# Access Compliance Report

## Public Rights-of-Way

### (Pedestrian Signals)

| ADA ID: A4B2EC8A51A6                    | Signal Type: One Push Button-APS | Overall Compliance: No                  | Severity Score: BTN 1: N/A BTN 2: N/A No BTN: N/A |

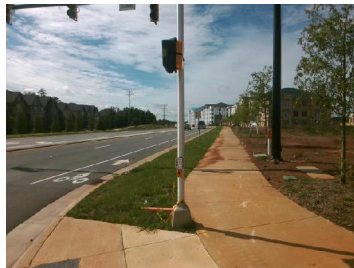
Surveyor Notes: OUT OF SERVICE

PROW/ADA: TMUTCD 4e.08, R404.2, R404.3, R406.2, R209.1, TMUTCD 4e.10, MUTCD 4e.08, R104.2,

Possible Solutions: Replace Signal Push Button With APS Button on New Post. Remove & Relocate Sign.
